**Vogtle Project**

March 26, 1986

NRC DOCKET NUMBERS 50-424 AND 50-425  
CONSTRUCTION PERMIT NUMBERS CPPR-108 AND CPPR-109  
VOGTLE ELECTRIC GENERATING PLANT - UNITS 1 AND 2  
MODIFICATIONS TO THE POWER BLOCK BACKFILL

FIGURE 1

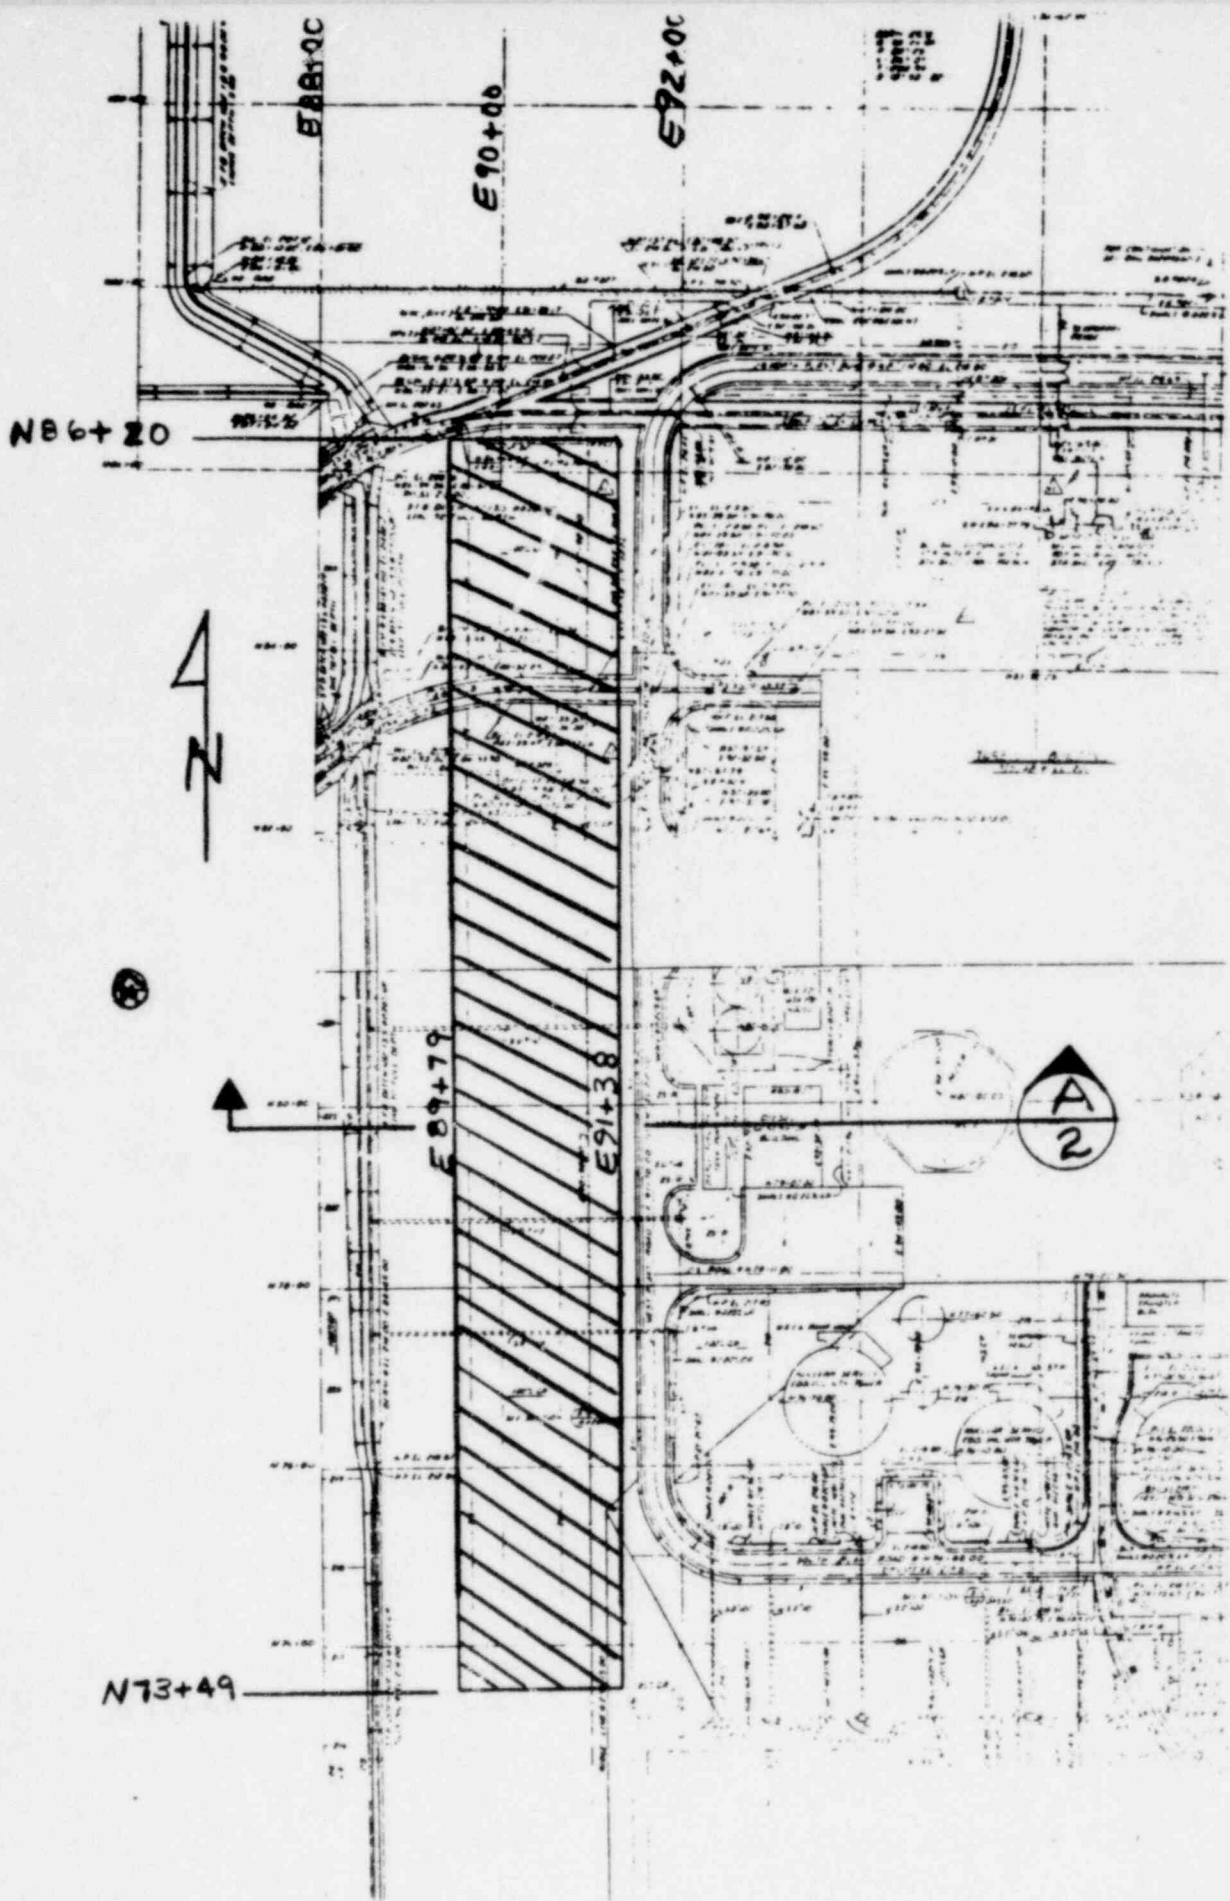
This is to advise you that Georgia Power Company (GPC) is making some minor modifications to the power block backfill as discussed below. None of these changes have any effect on safety-related structures, systems or components. The top layers over the in-situ slopes forming the west side of the power block excavation and above elevation 206 will be backfilled with Category 2 material to 95 percent of the maximum density determined in accordance with ASTM D 1557. This area, which is bounded by the coordinates N73+49 to N86+20 and E89+79 to E91+38 and shown in Figures 1 and 2, was previously considered a part of the Category 1 backfill area.

- o The top layers are above the water table and will not affect the liquefaction analysis. Although as explained below liquefaction in this area would not be a licensing concern.
- o The area is above the excavation slopes which are composed of in-situ soils and are therefore not used to support Category 1 structures, systems, or components.
- o The area is remote from Category 1 structures and will not affect their foundation support in any way.
